## **National Paediatric Hospital Development Board**

**Project No.: 011782**

## **Emergency Department Concept Options Analysis**

EMERGENCY DEPARTMENT - OPTION 1

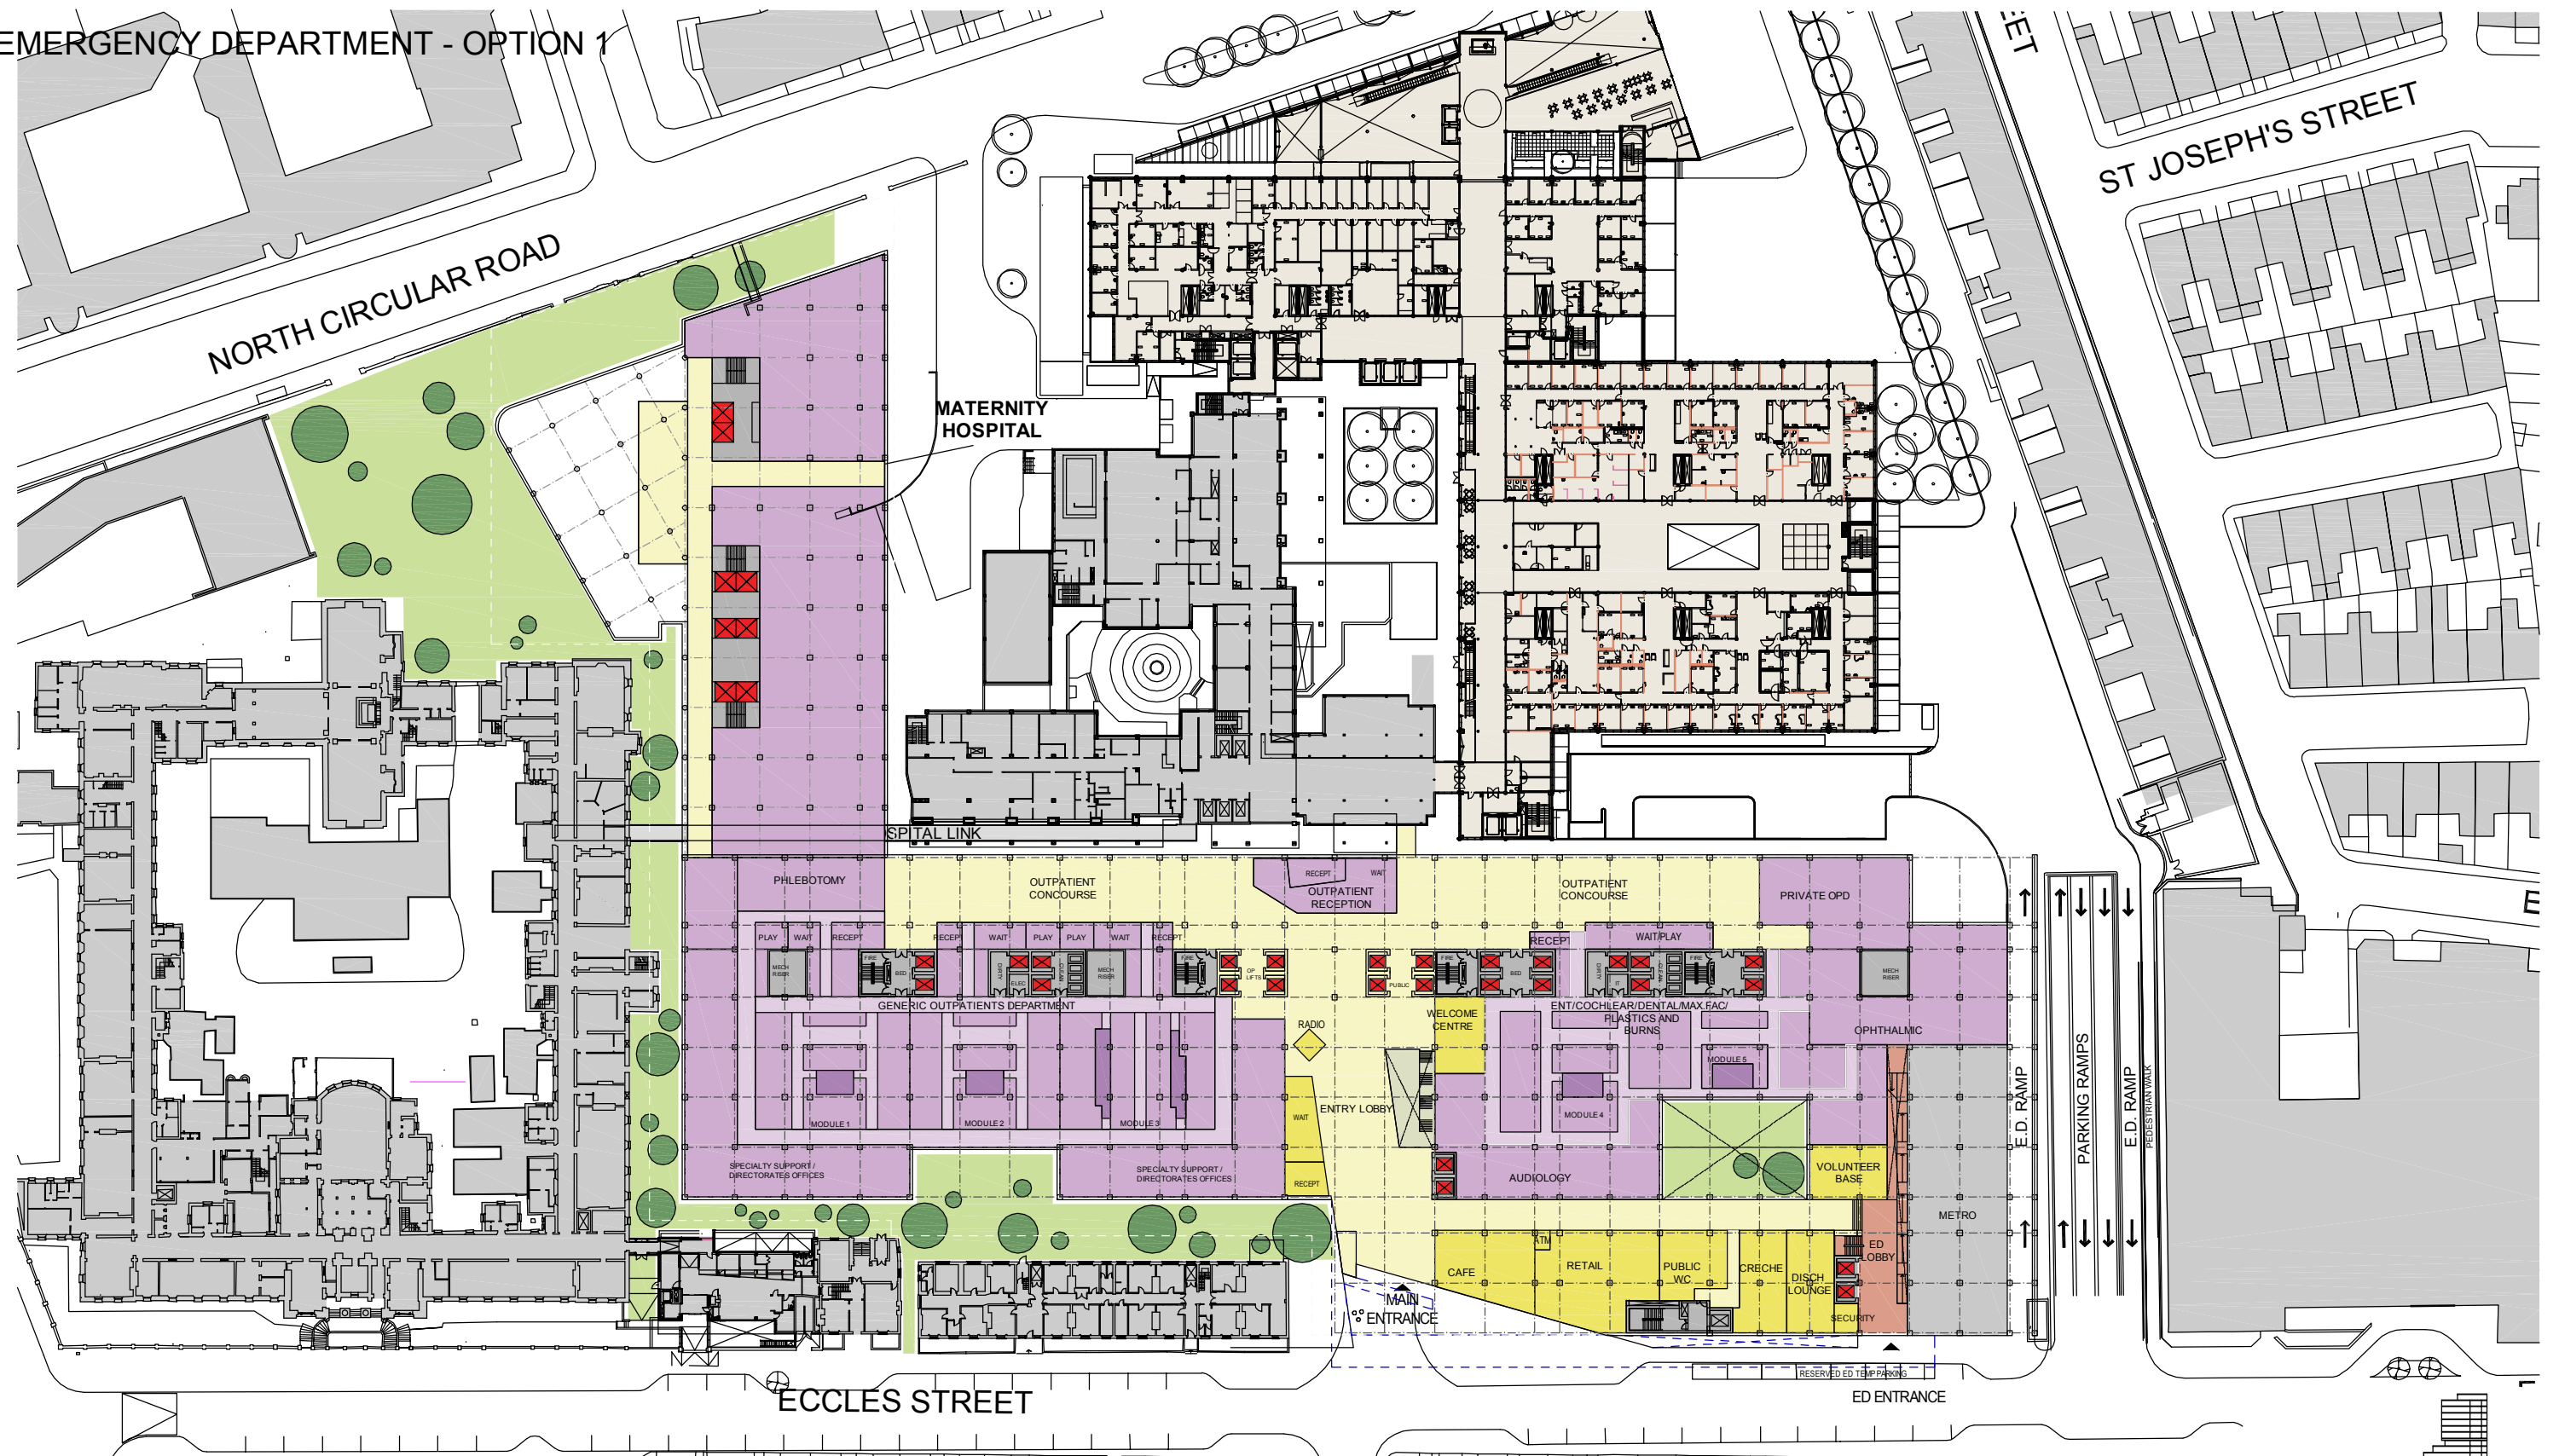
- a. Option 1 has the added risk of requiring people to descend stairs/ramp and again due to the possible distracted state a higher risk of trip and fall hazards. We note that a lift is available.

# EMERGENCY DEPARTMENT - OPTION 2

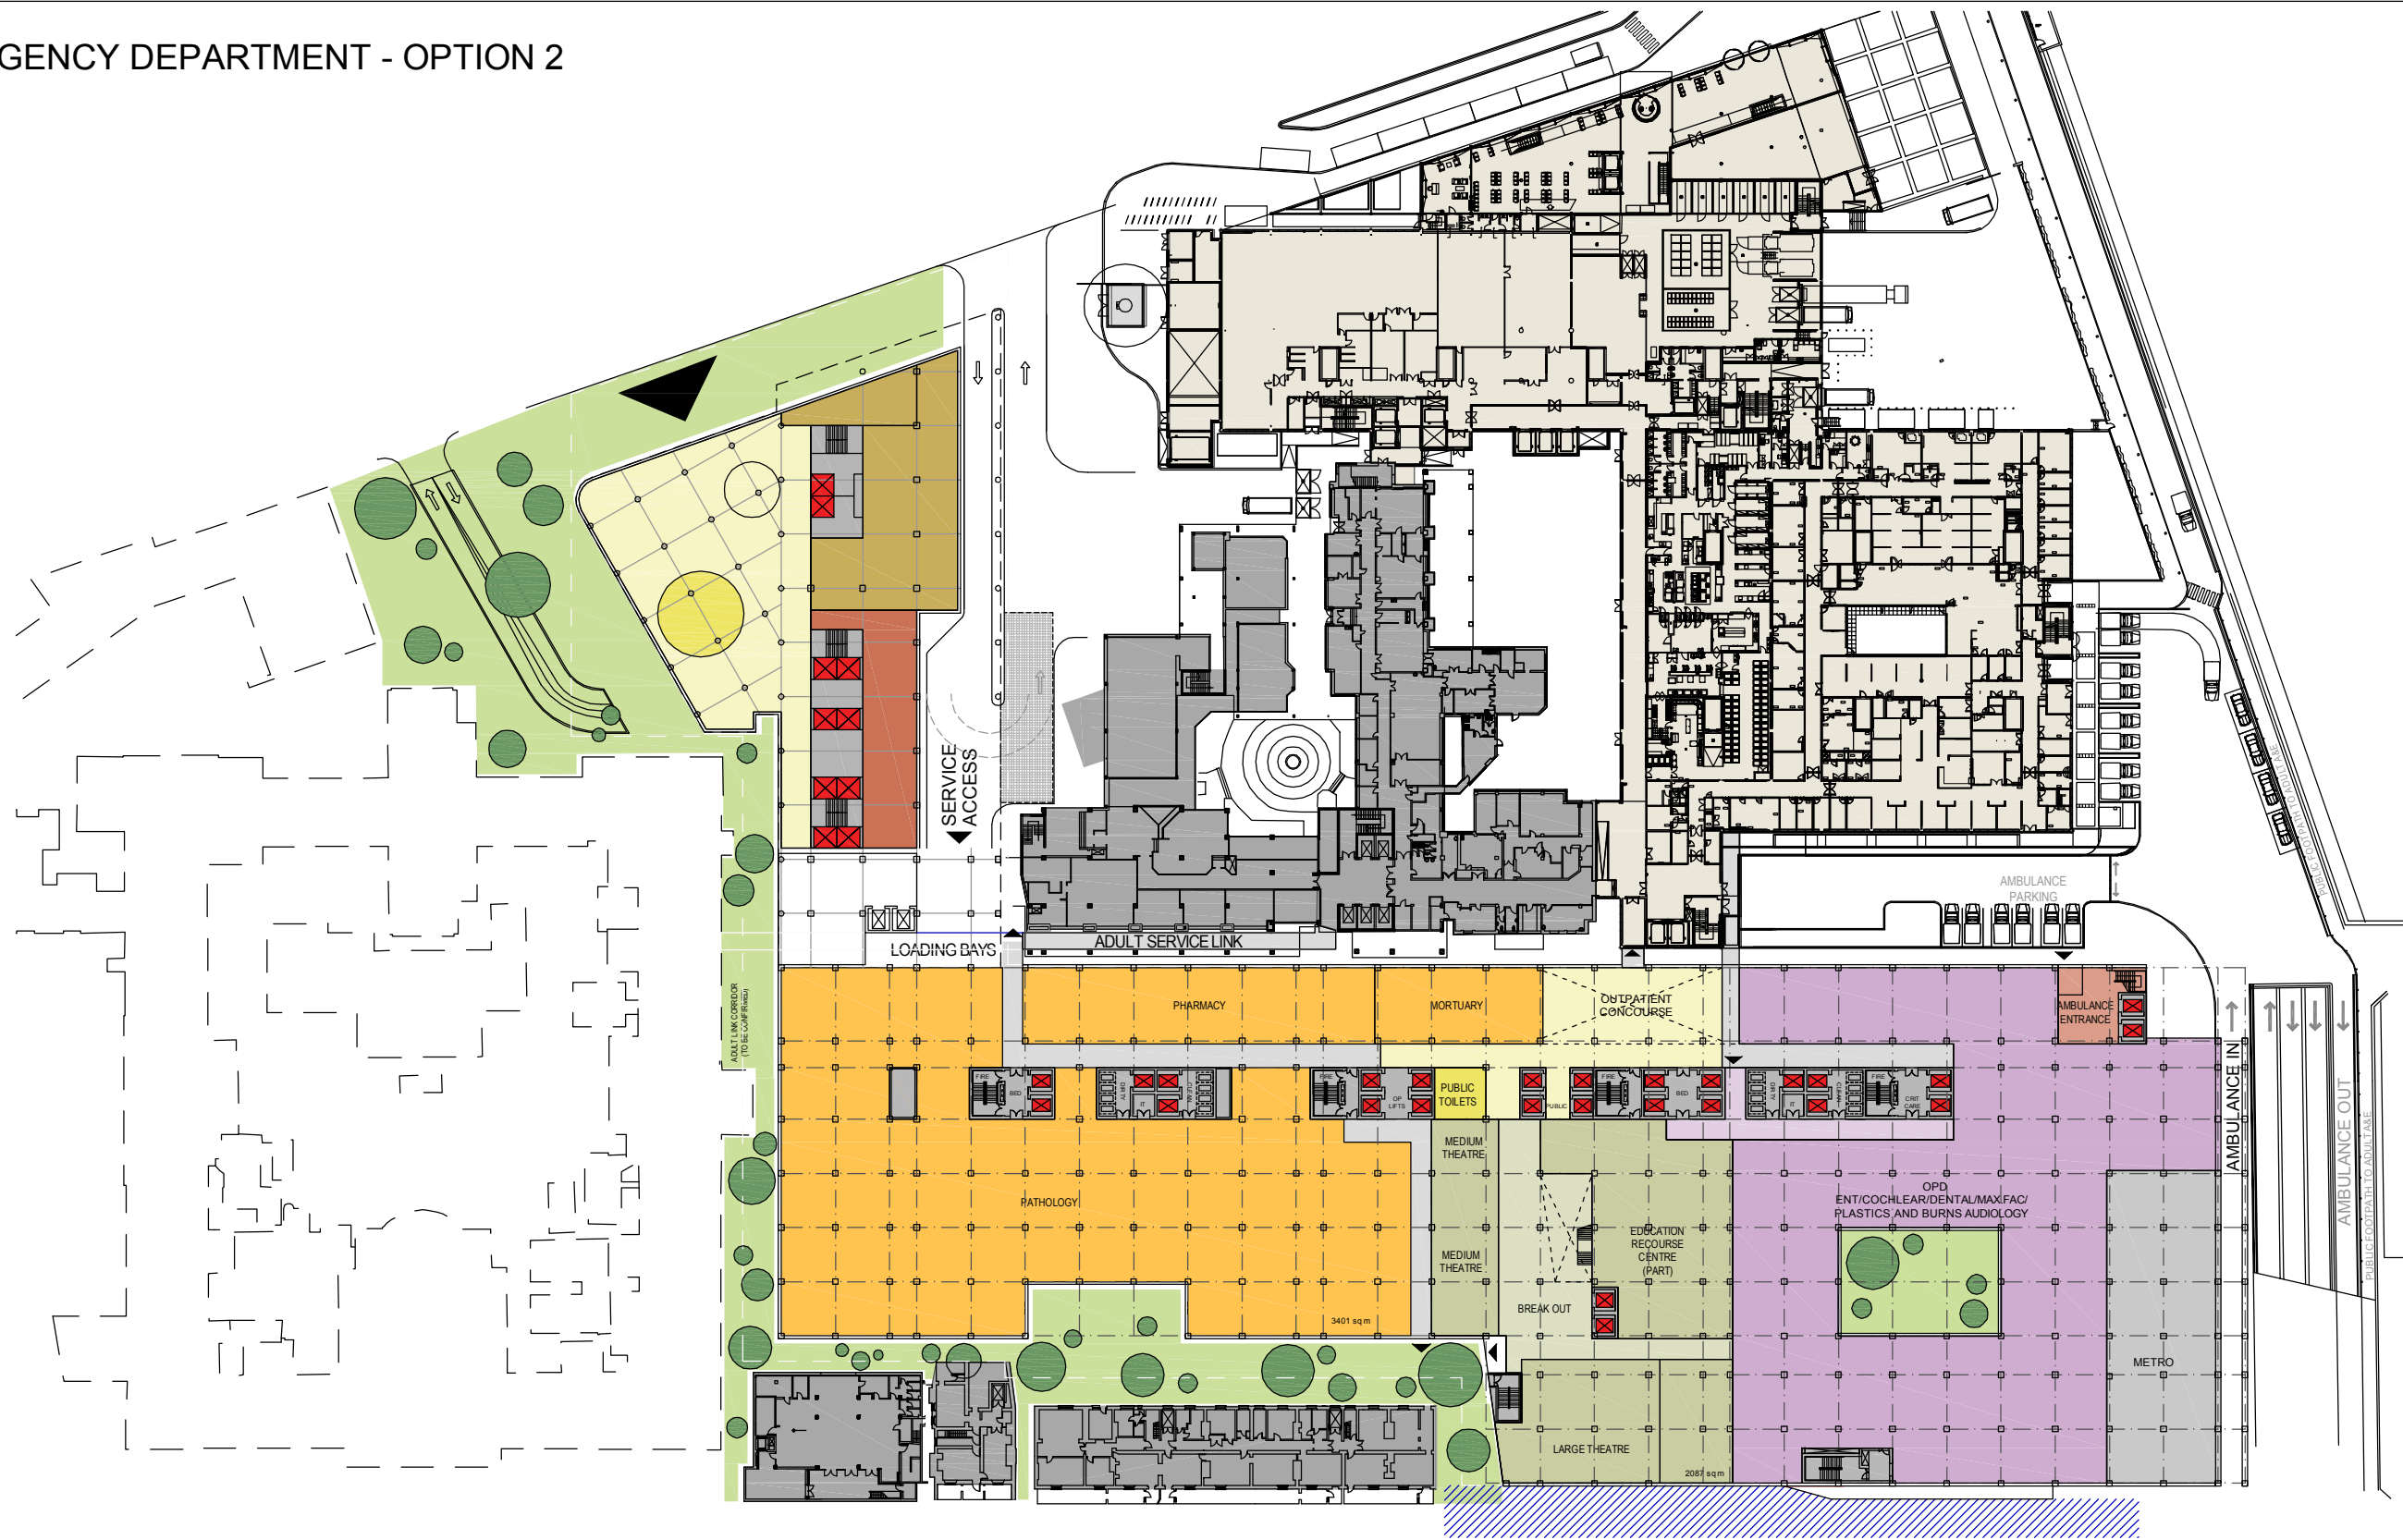
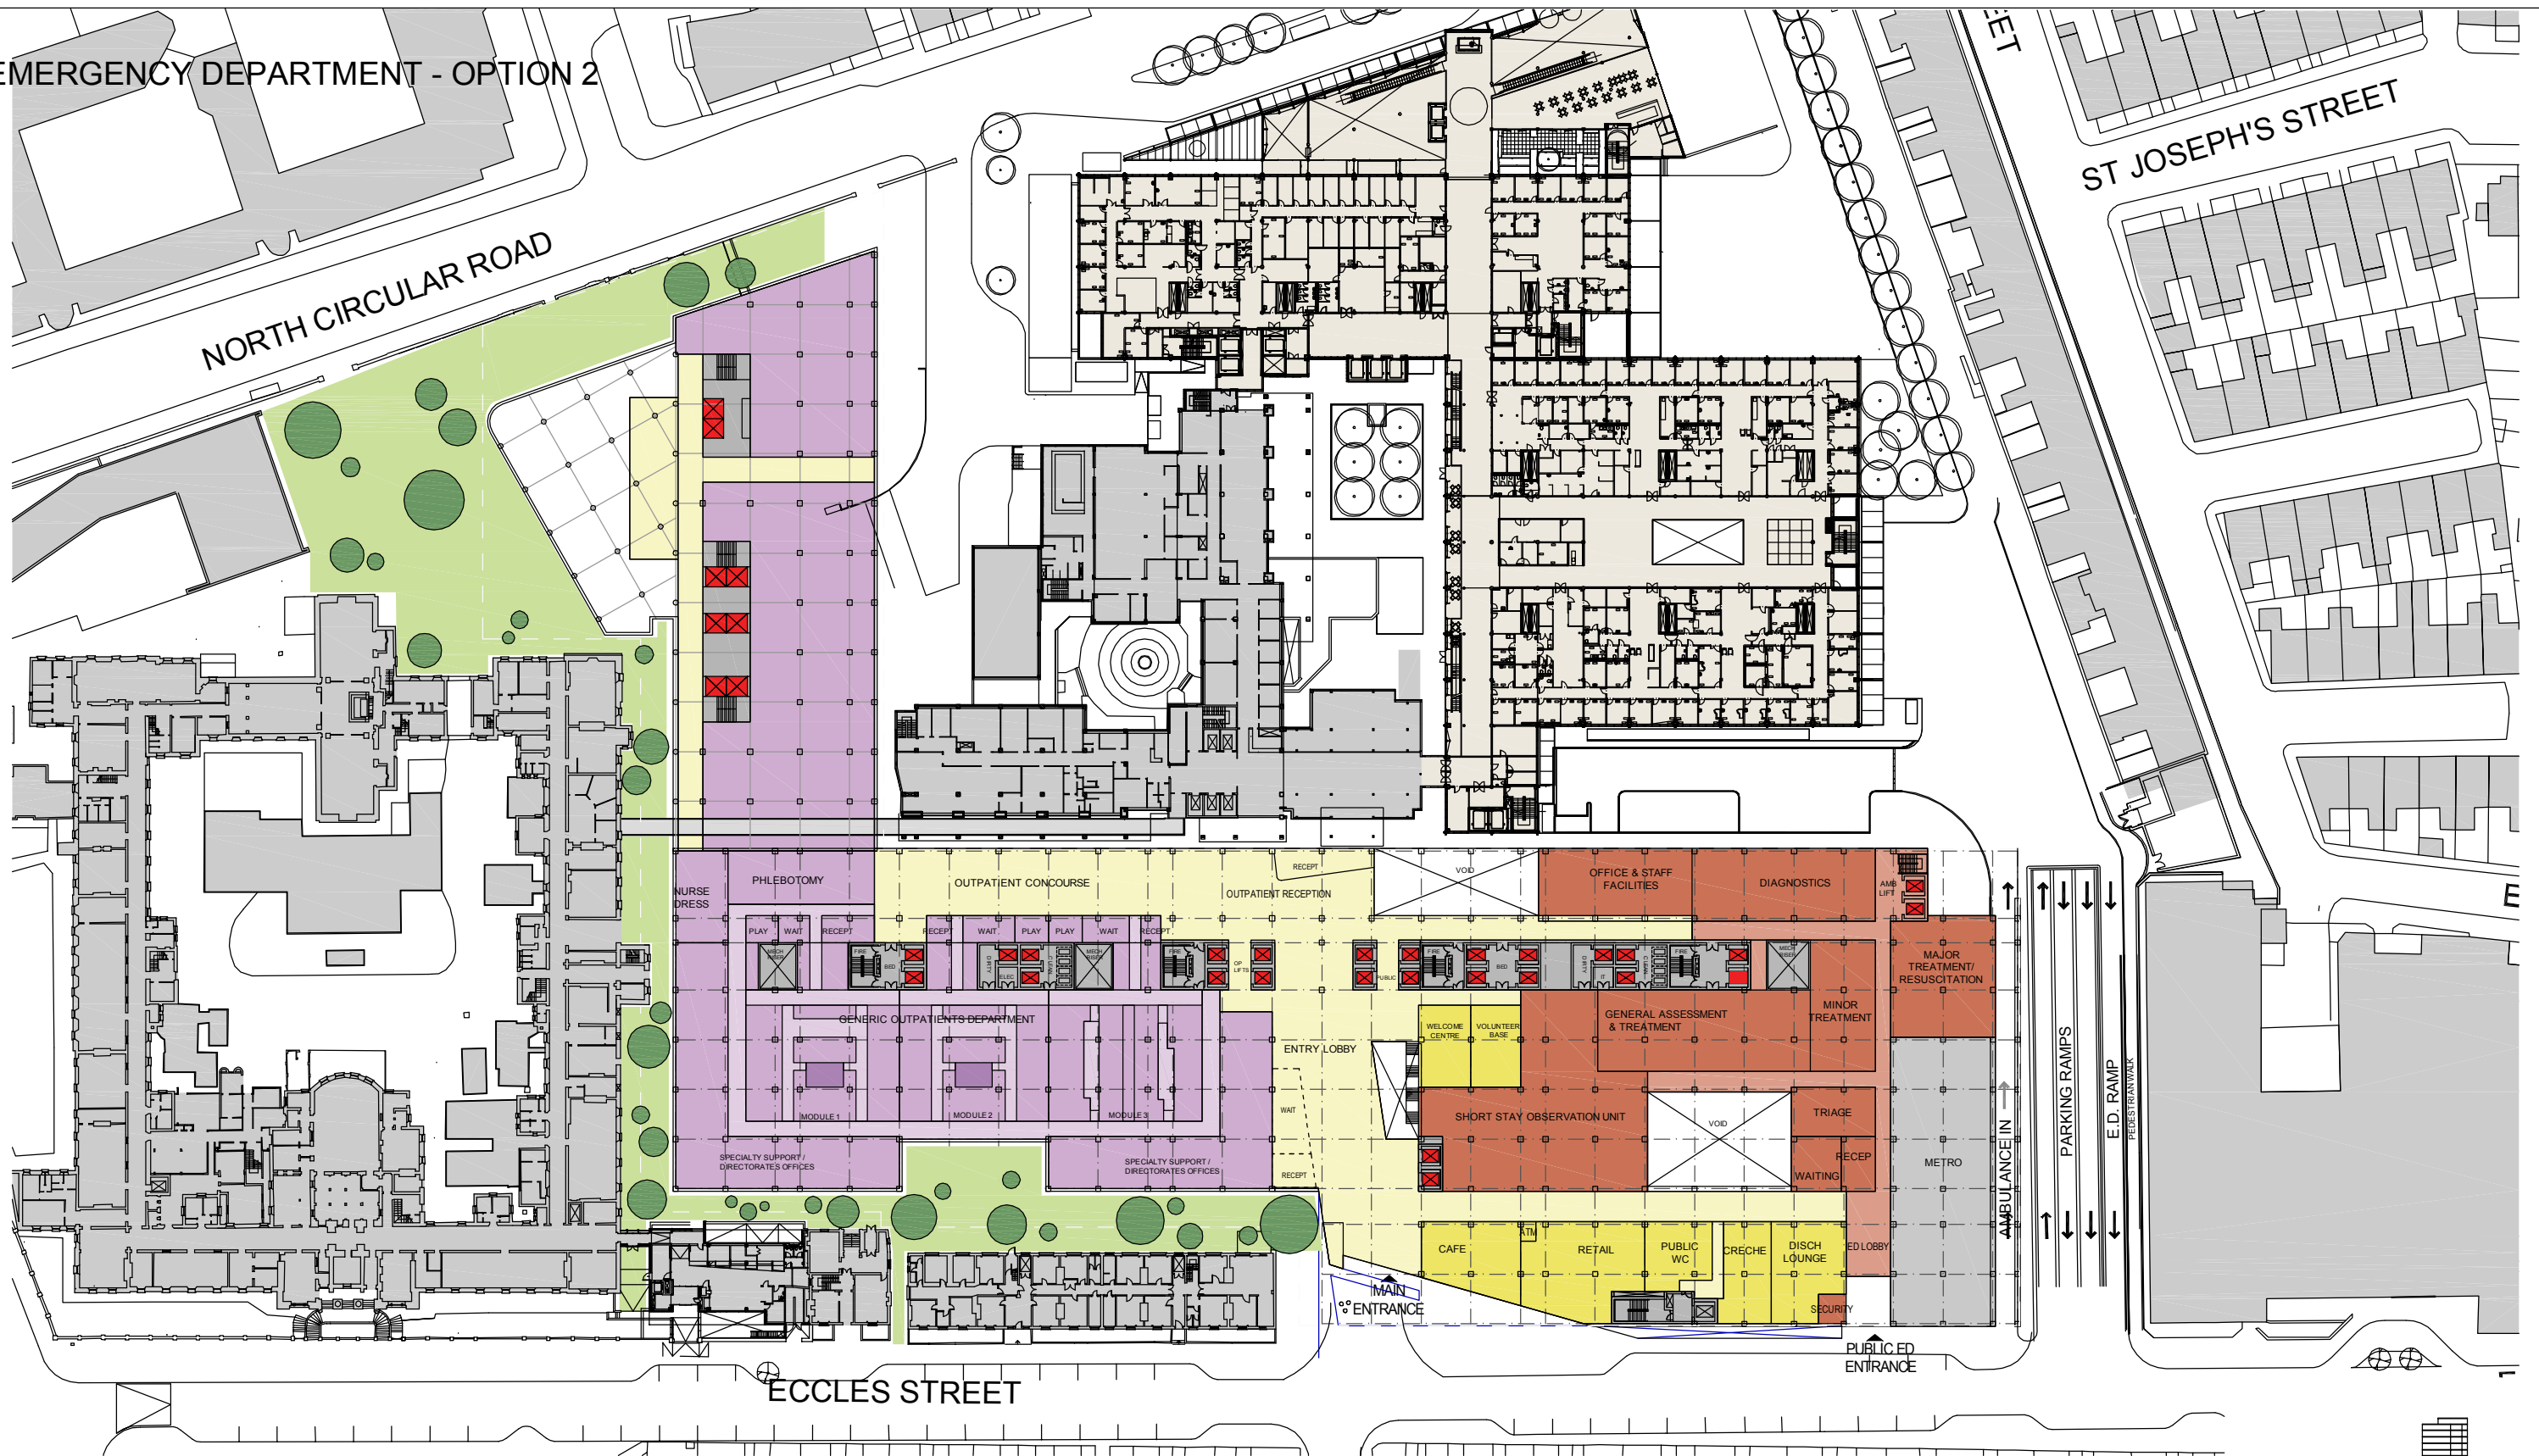
- b. Option 2 has the added risk of requiring lift access from the ambulance bay and therefore a requirement to ensure reliability of the lifts, assuming that the majority of ambulance admissions are not ambulant. The Hospital will also require procedures for coping with downtime during statutory testing.
